Design Review Update

Parcel W

Reference: Parcel W Design Review
Cambridge Crossing
Cambridge, Massachusetts

CAMBRIDGE PLANNING BOARD ON NOVEMBER 13th, 2018

NORTH BUILDING SECOND FLOOR PLAN

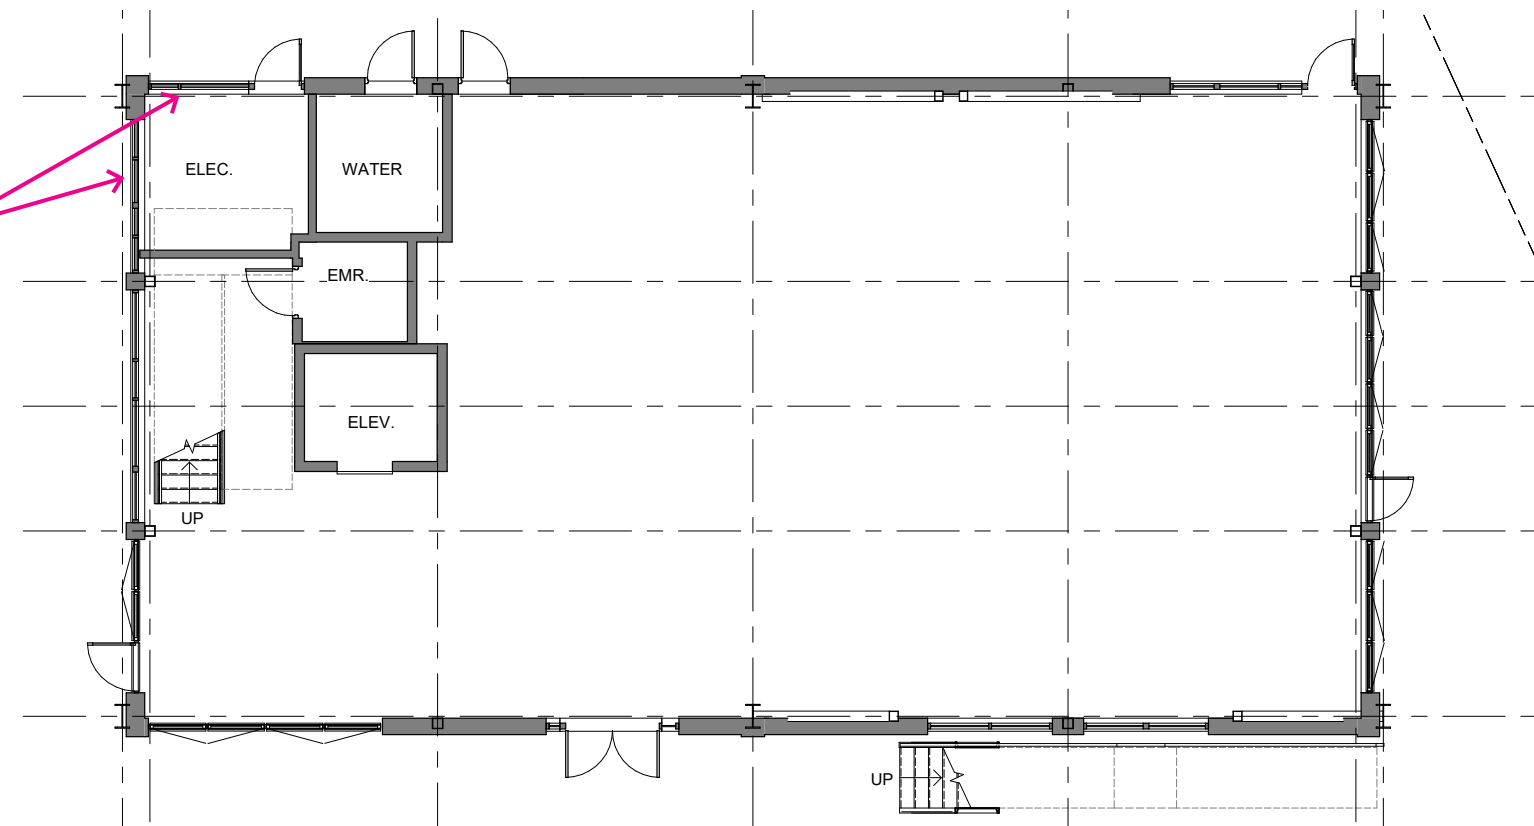
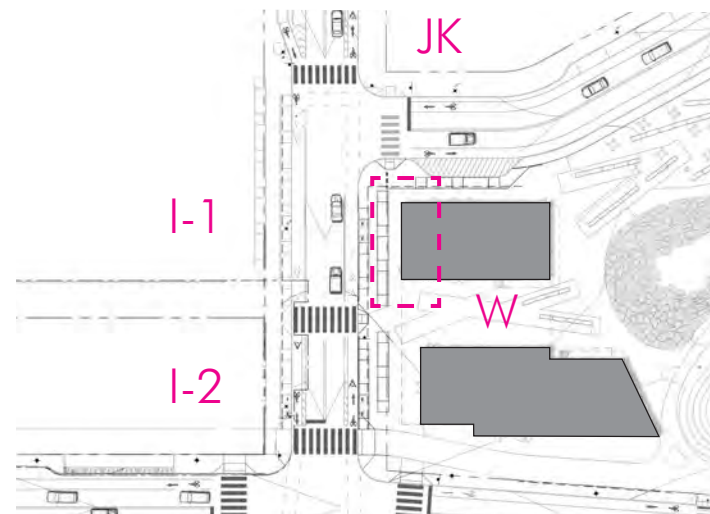
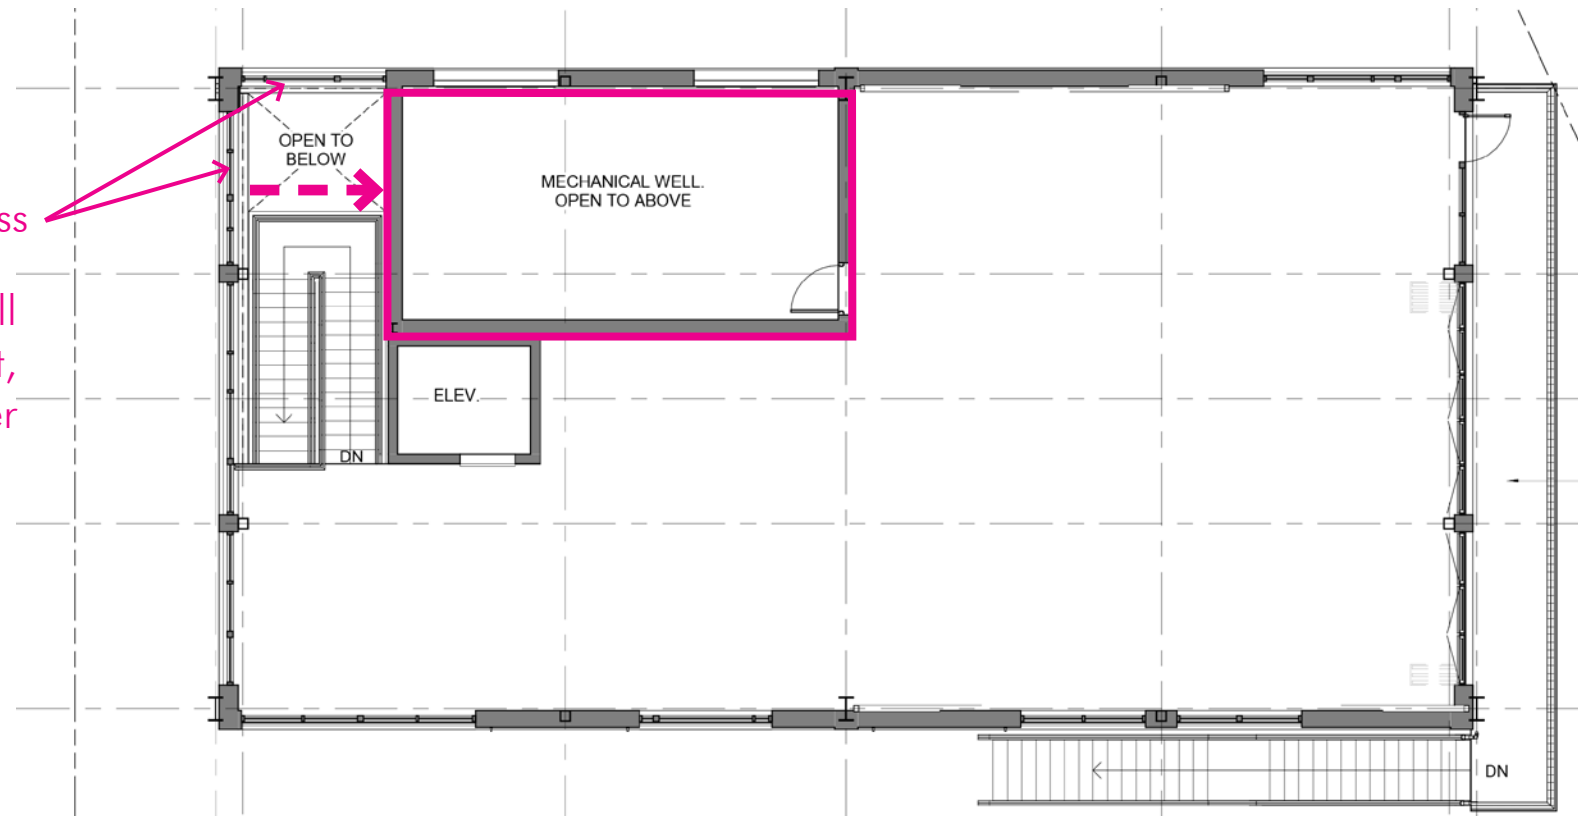
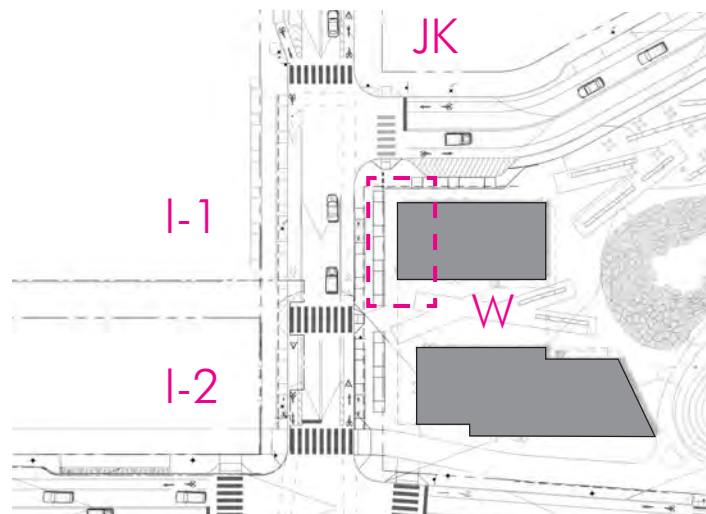
<i>North Building</i>		
The introduction of operable glass walls facing the Common, plaza and North First Street is supported as this reduces the distinction between interior and exterior, and helps activate the public realm.	No action required.	
Relocation of the electrical and utility rooms, and the mechanical well, to the northwest corner of the building is a concern. This change results in the entire corner being encased in spandrel glass or louvers, rather than transparent glass as was approved. This corner is quite important from a pedestrian's perspective as one is walking on North First Street, and there has not been a subsequent increase in transparency of the north elevation.	The core elements of the North building have been redesigned in a way that we believe is both satisfactory to urban design desires and tenant operational desires. The stairs have shifted plan south, while the electric and water rooms have shifted plan east, creating an open, transparent, two-story space large enough for active tenant uses.	4-8

1. NORTHWEST CORNER TRANSPARENCY

Relocated mechanical well allows for double height, transparent corner

Relocated utility rooms and stair allows for double height, transparent corner and area for additional seating

2017 APPROVED WEST ELEVATION

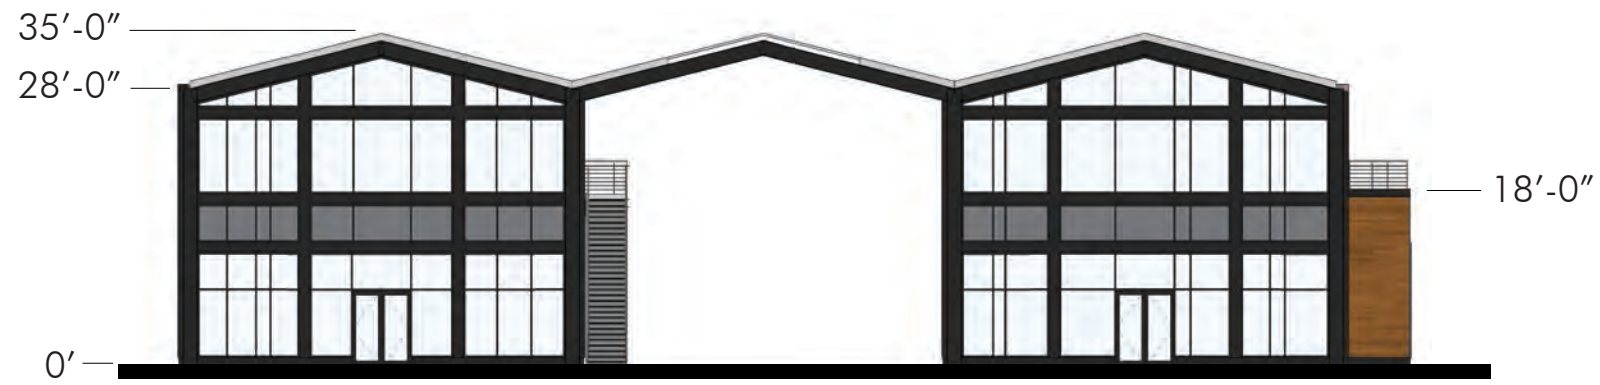
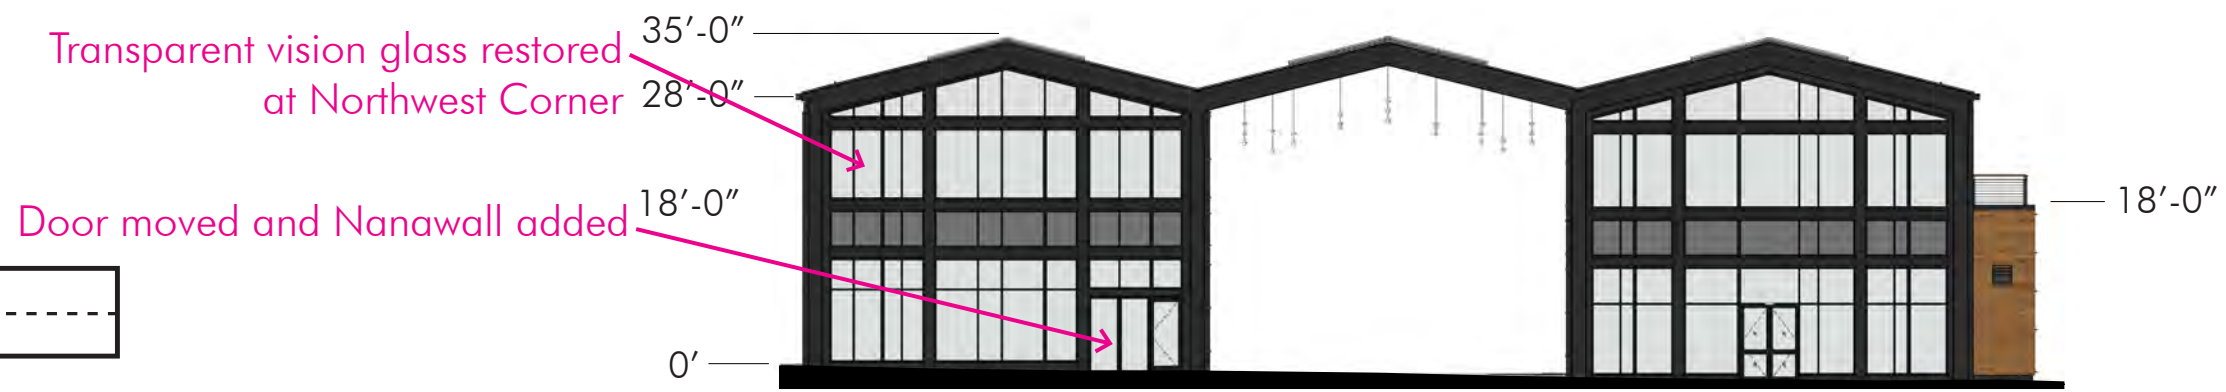
1. NORTHWEST CORNER TRANSPARENCY

Mechanical spaces moved away from East facade and Transparent vision glass restored at Northwest Corner

South Building Second Floor Plan

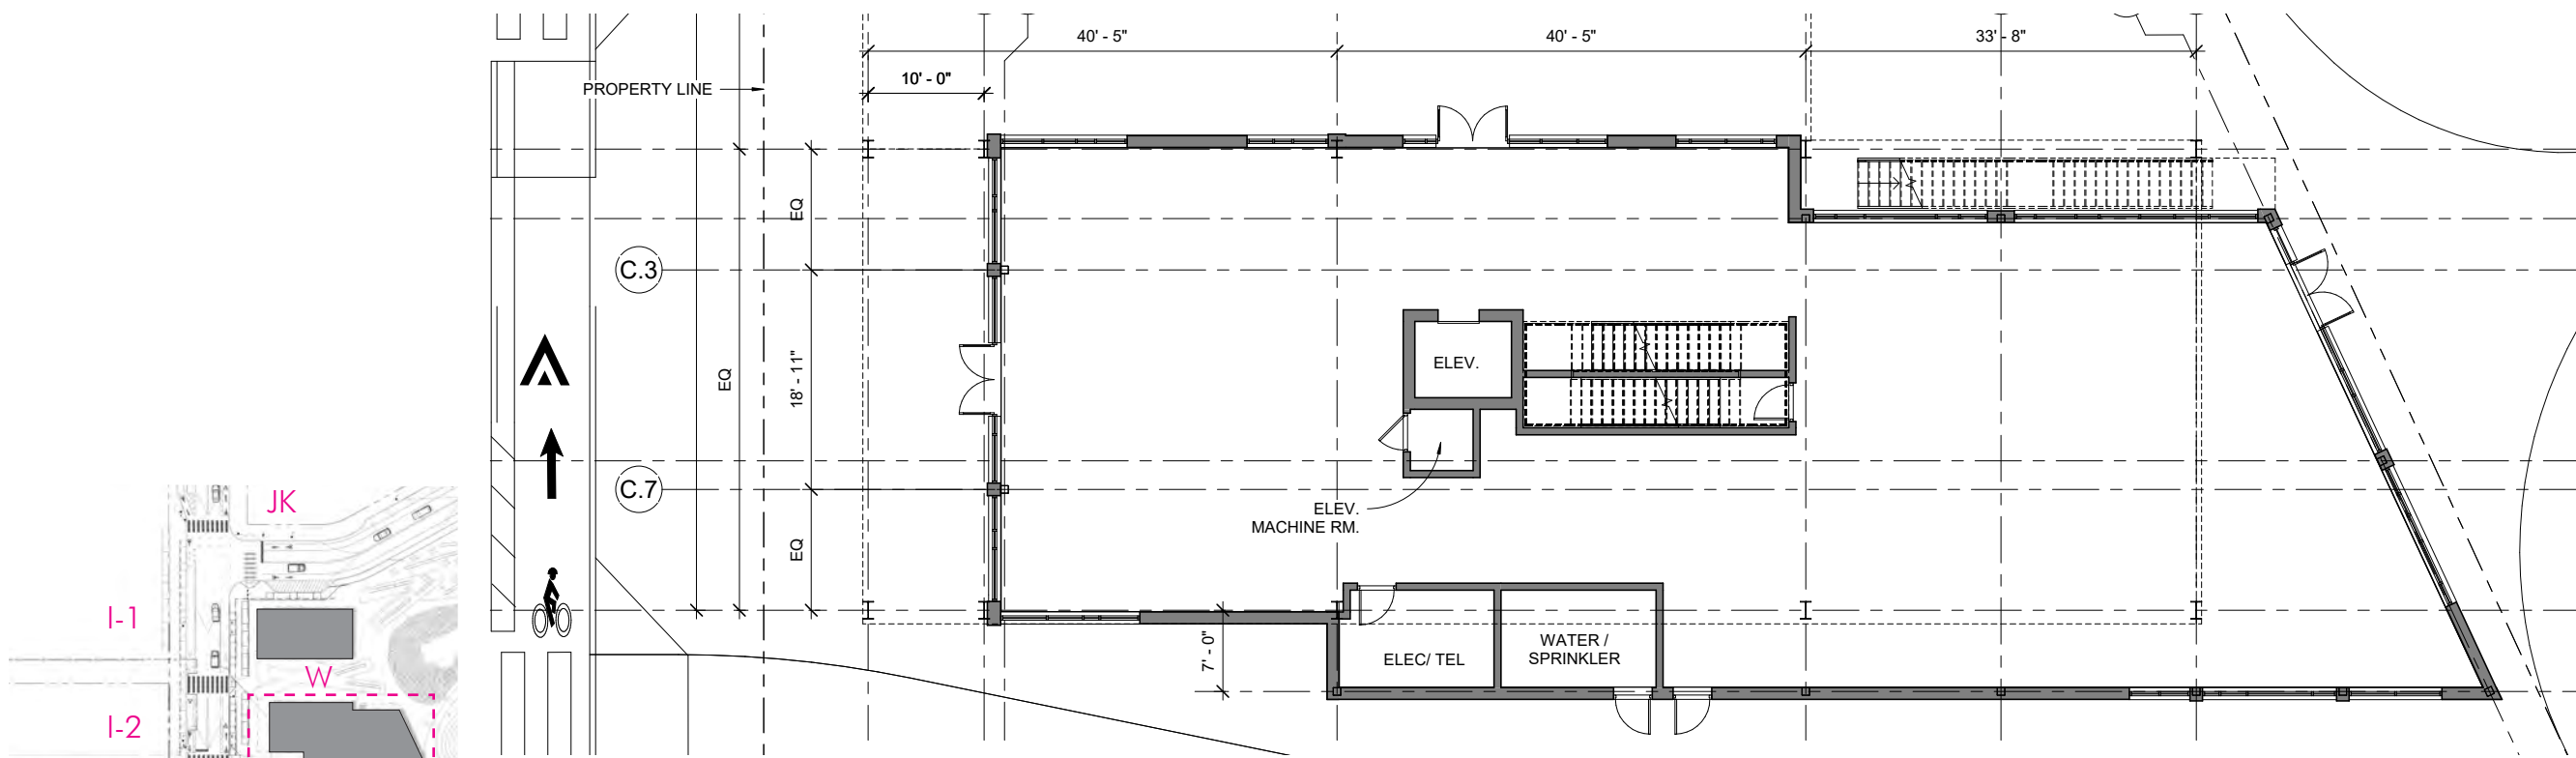
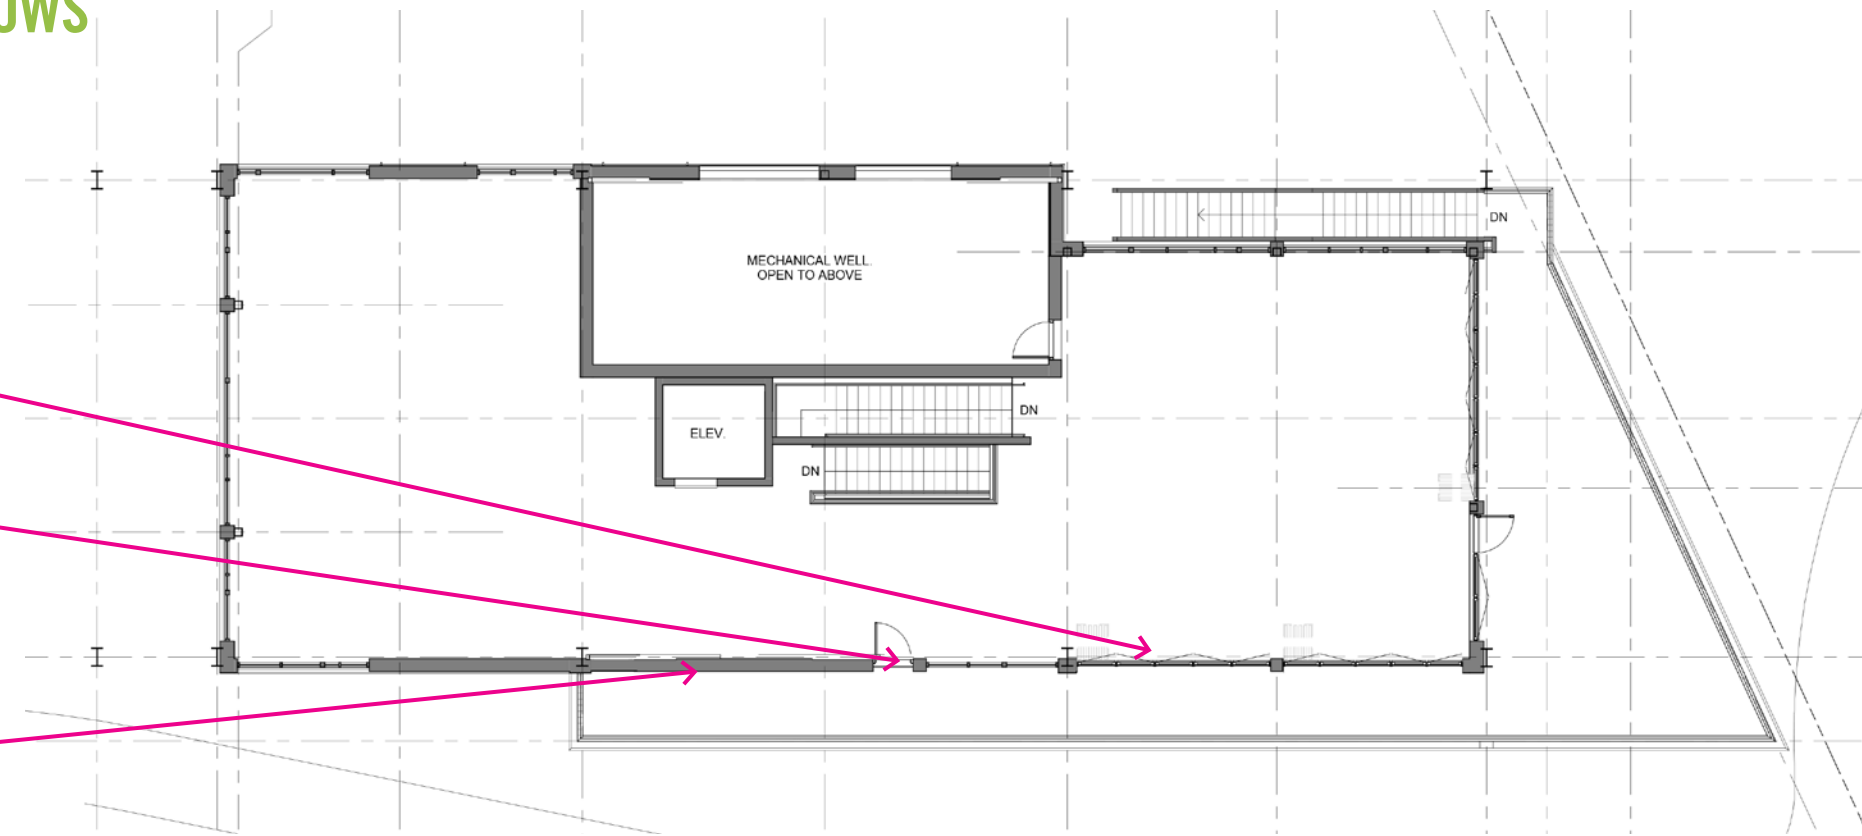
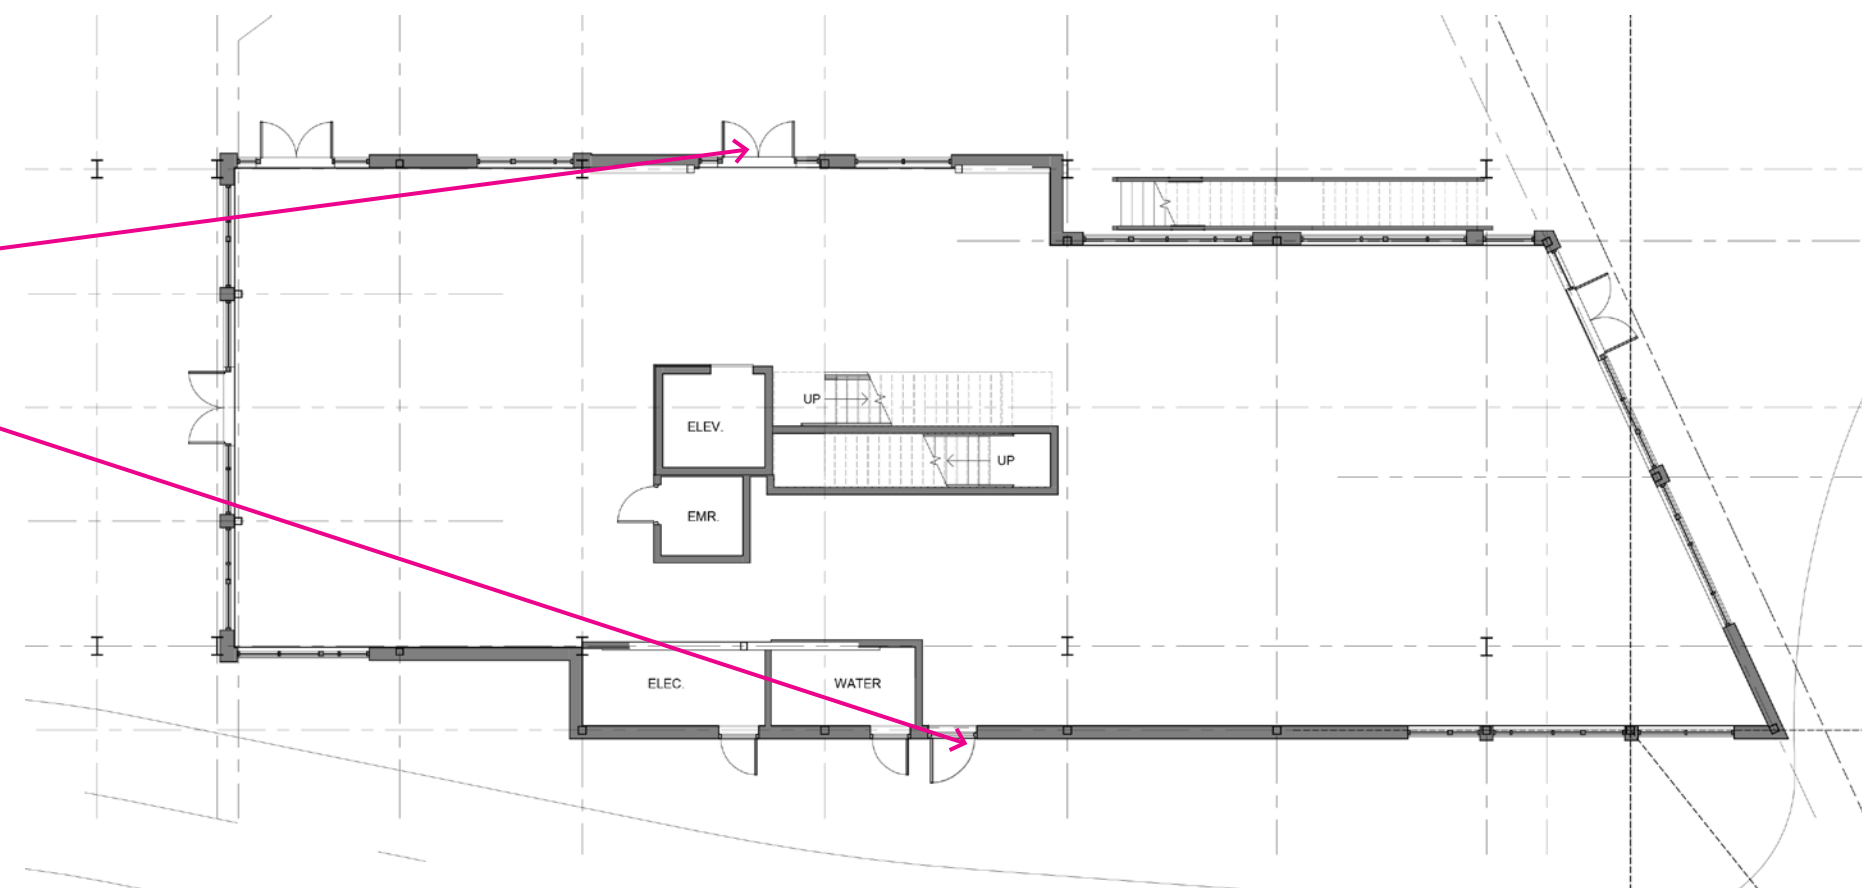
2. SECOND FLOOR SOUTH WINDOWS

- Nanawall
- Door relocated
- Second floor glazing changed to accomodate structural cross bracing

- Door added
- 6" wider door

2017 APPROVED SOUTH ELEVATION

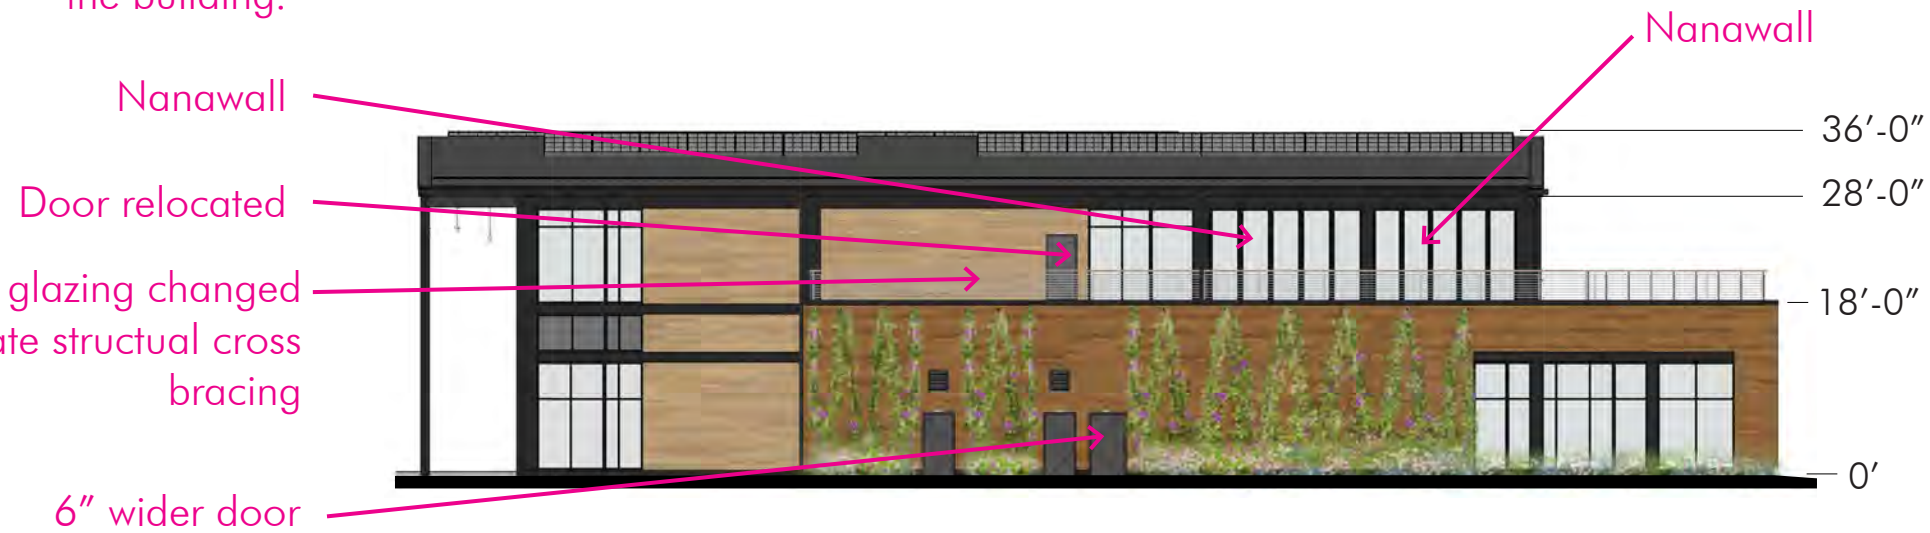
2. SECOND FLOOR SOUTH WINDOWS

There is no net decrease in glazing in the building.
